ADDENDUM
NO. 3

April 17, 2026

**TRI-TOWNSHIP WANATAH SCHOOL
RENOVATION AND RELATED WORK
Wanatah, IN 46390**

This Addendum consists of Pages ADD 3-1 through ADD 3-4, and attached Addendum No. 3 from Gibraltar Design dated April 16, 2026 and consisting of 5 pages, replacement Specification Section 33 40 00 - Storm Sewage Systems, and 15 drawings.

GIRLS LOCKER ROOM FLOOR PLAN
4
1/4" = 1'-0"

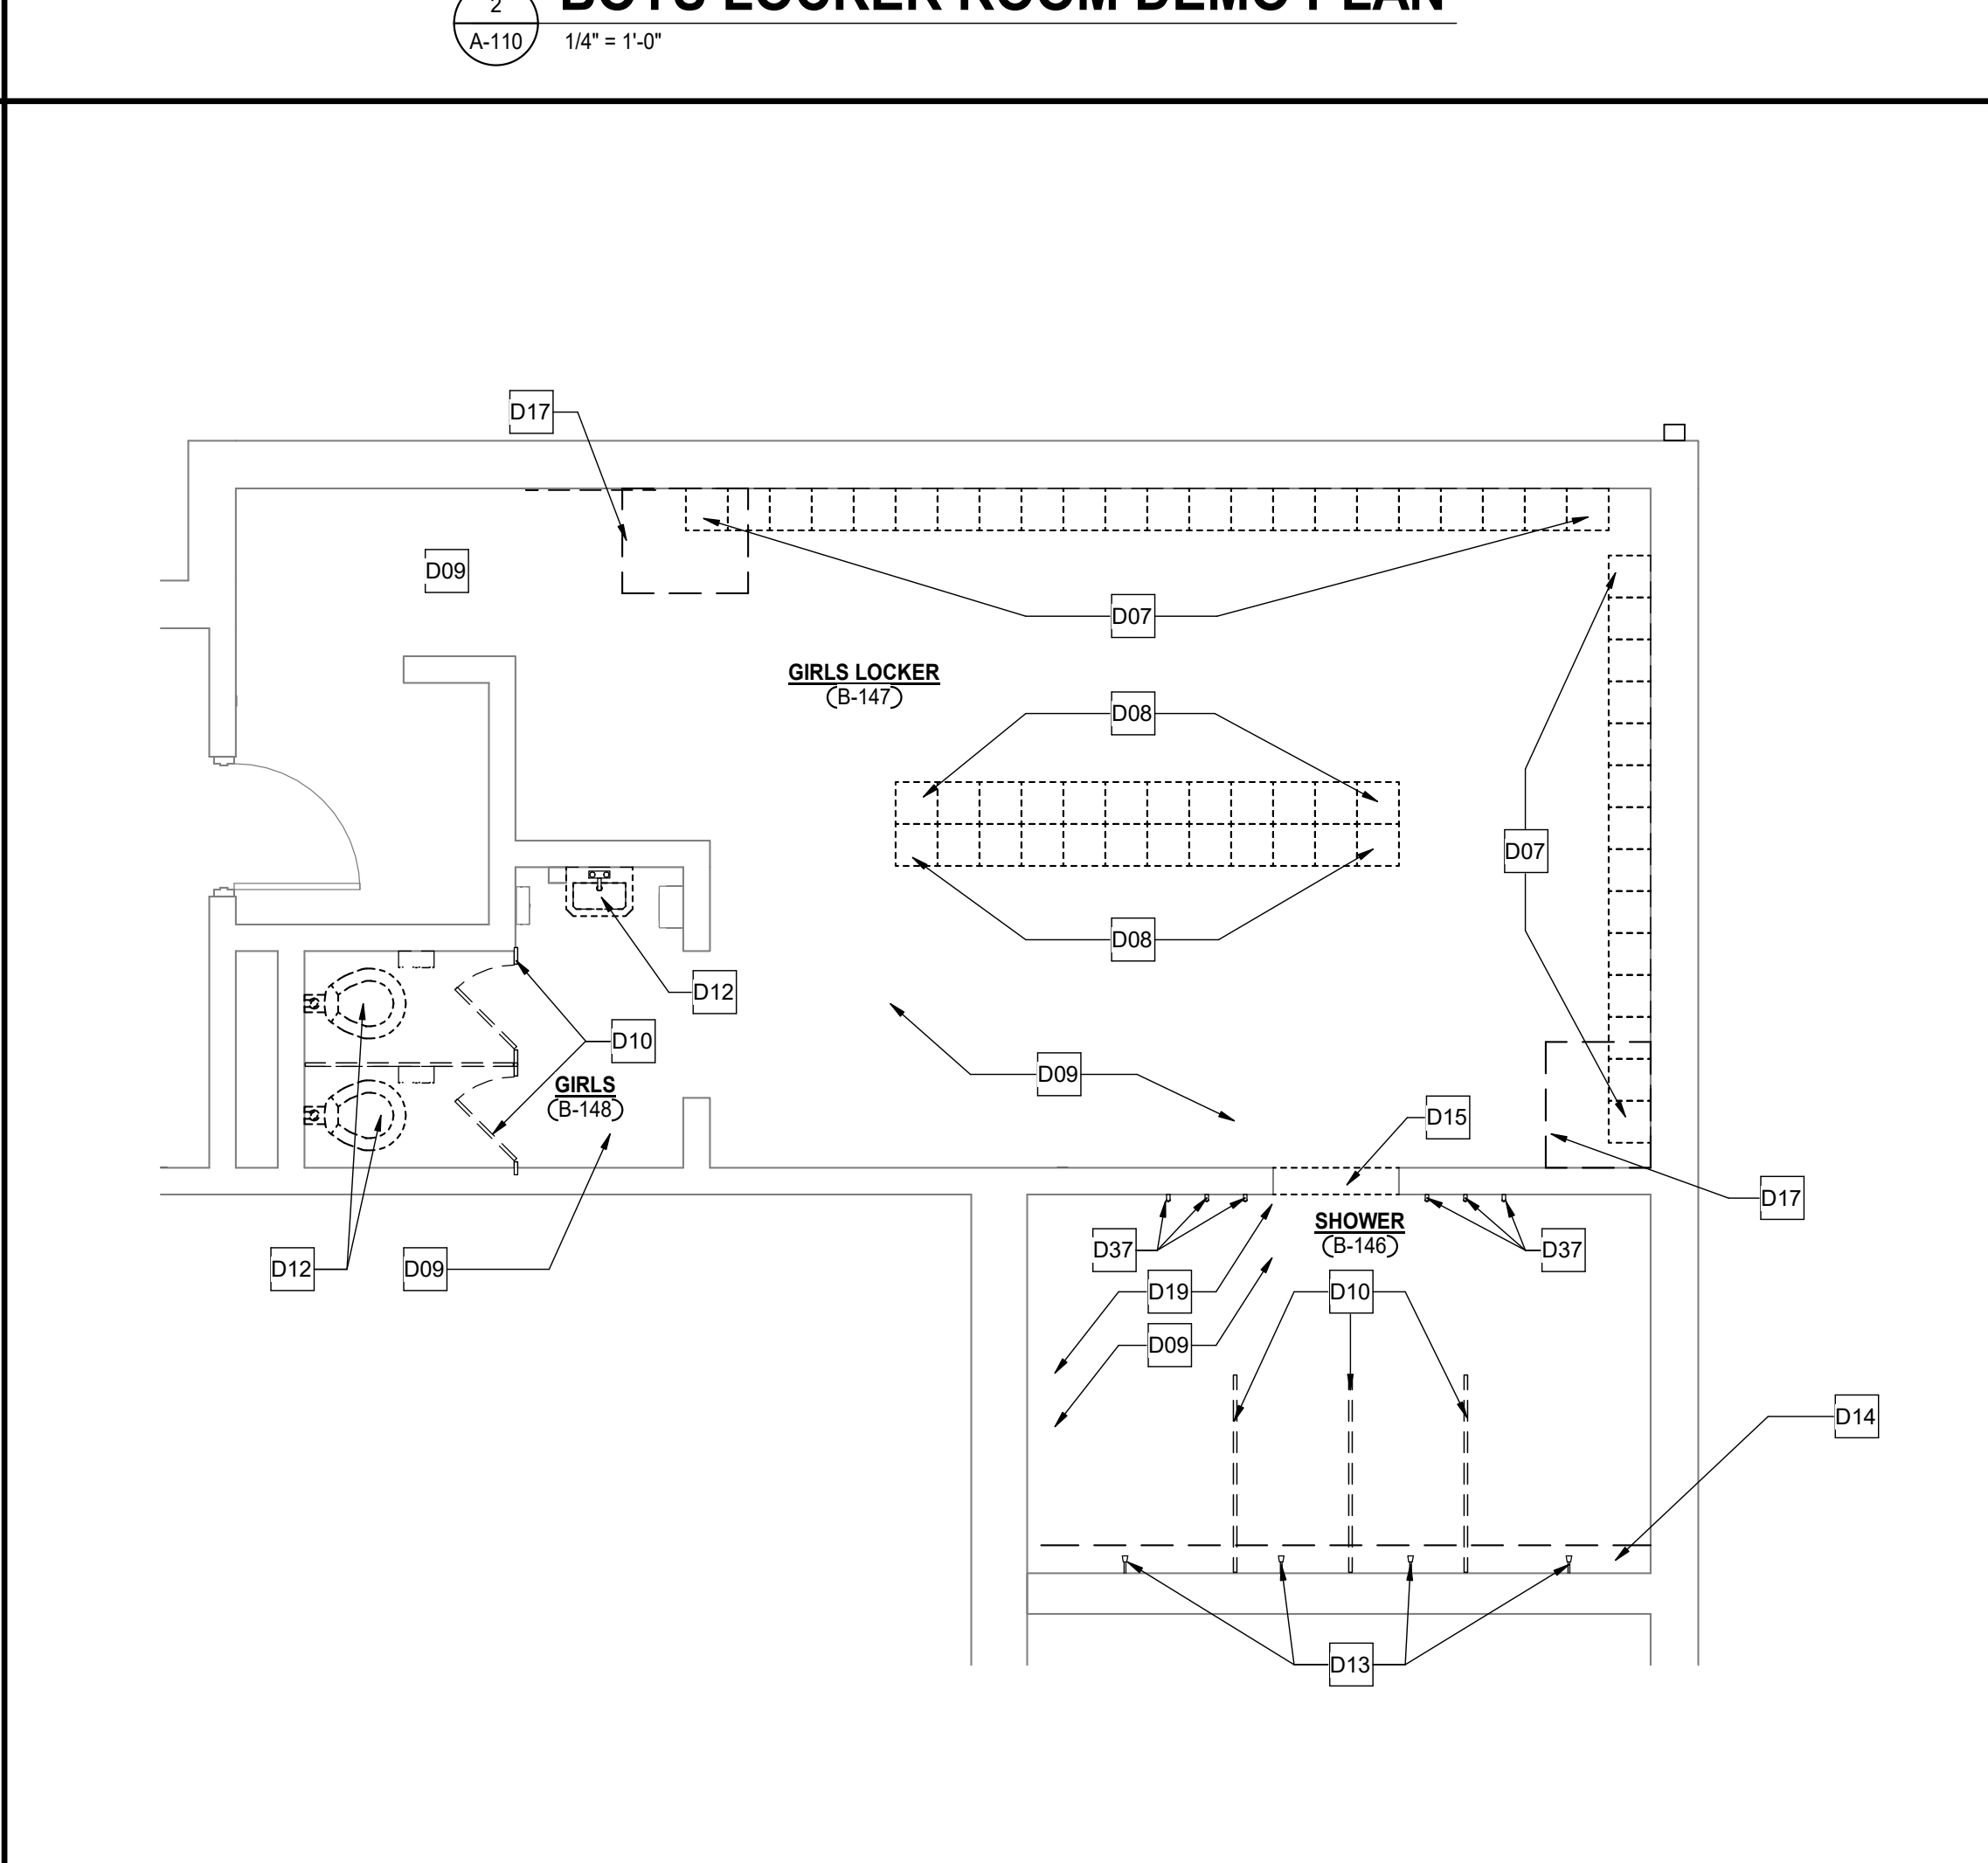
17. Sheet A-110

- A. Refer to revised, full-size drawing, for clarifications to wall framing, trench drain, and wall section detail for Shower Rooms B-146 and B-155, included in this Addendum, for clarifications.

© GIBRALTAR DESIGN SHEET **A-140**

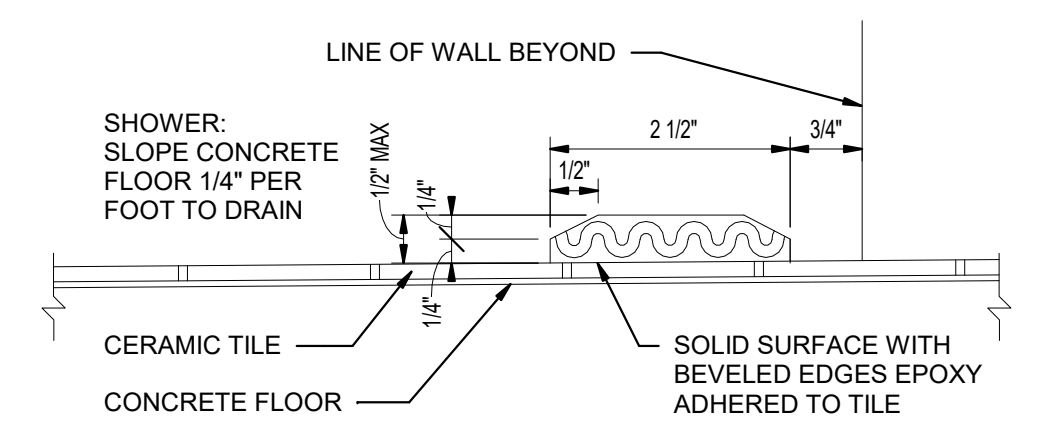
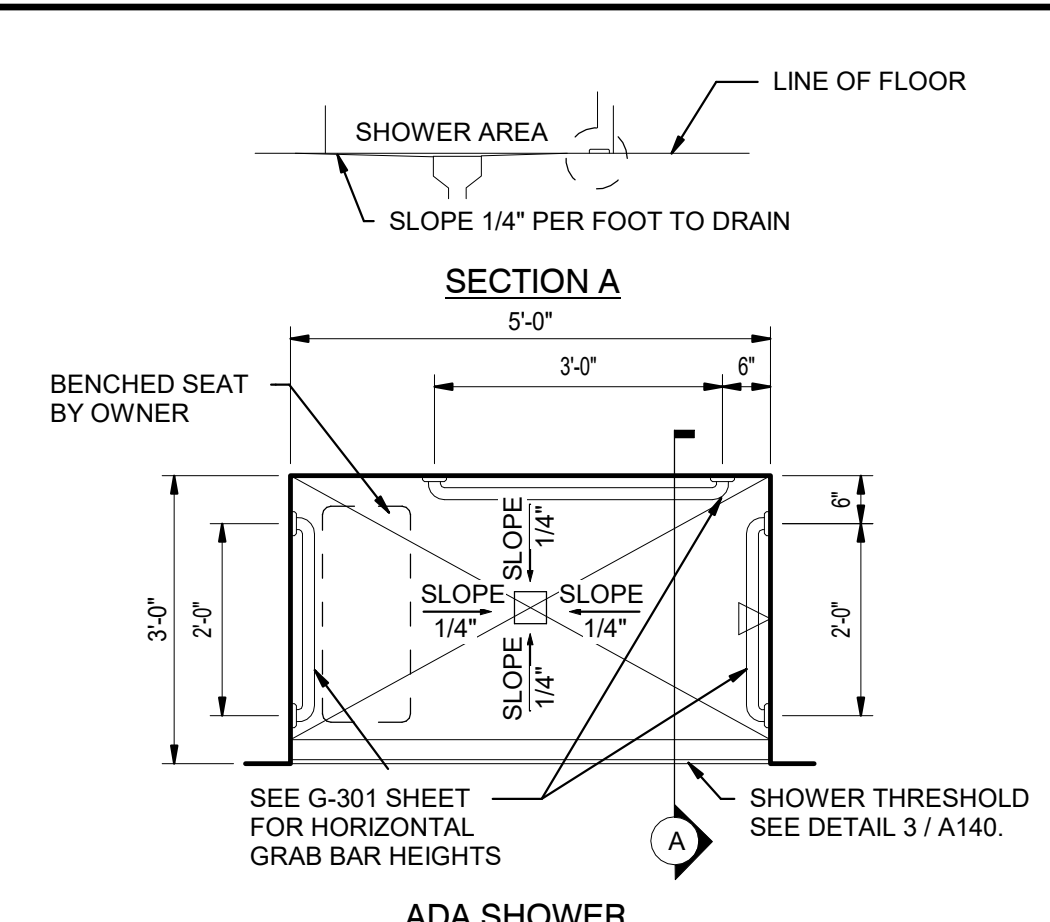
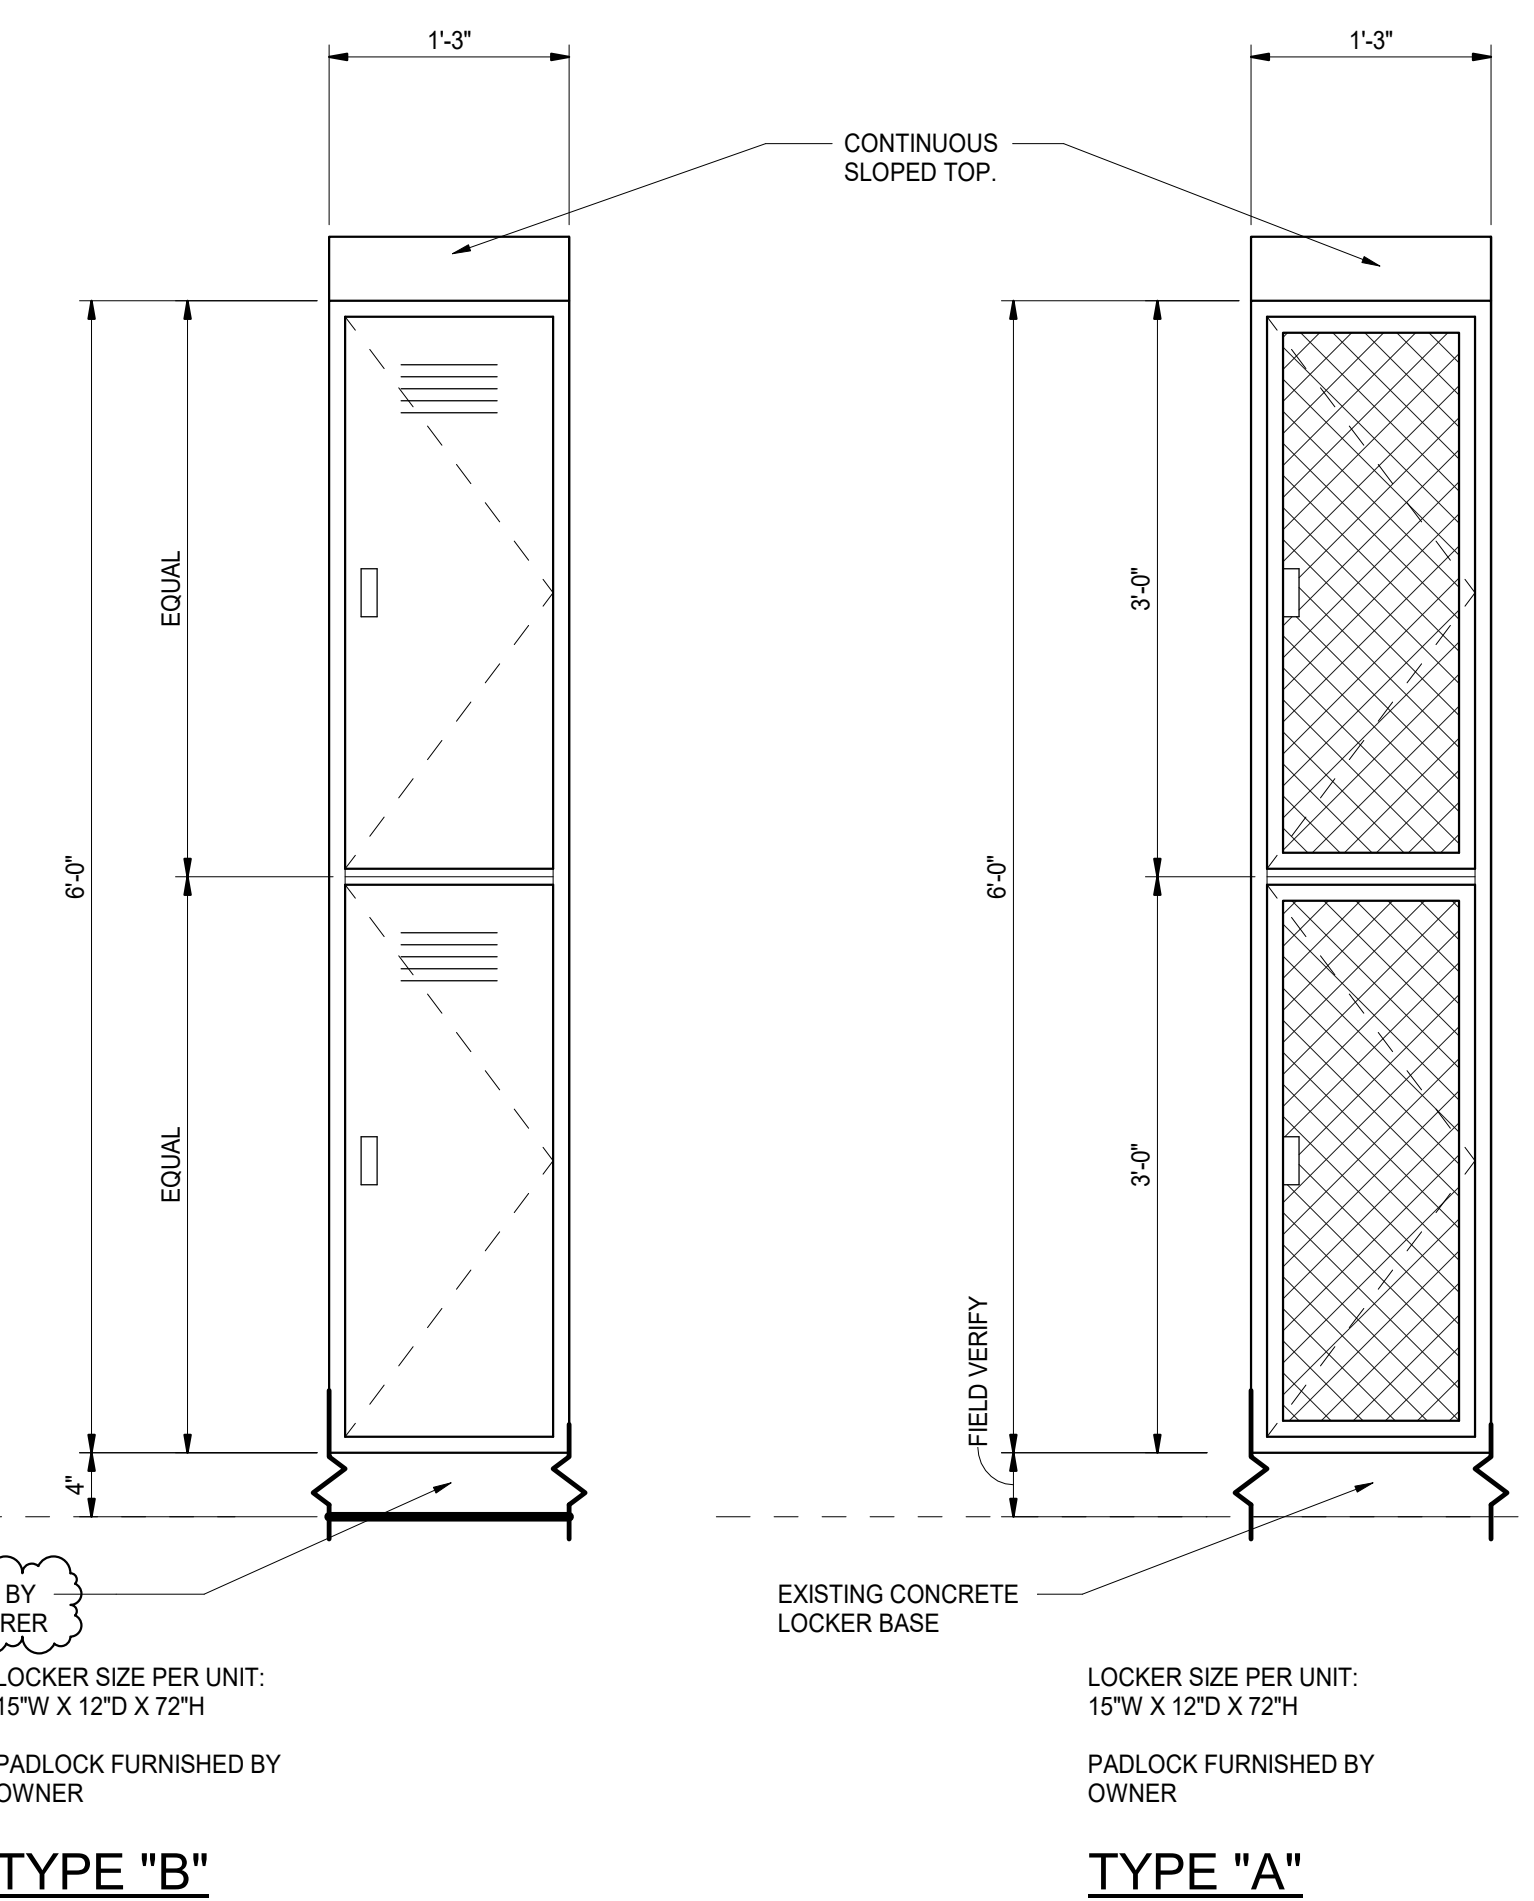
18. Sheet A-140

- A. Refer to revised, full-size drawing, detail corrections and Plan Note update, included in this Addendum, for clarifications.
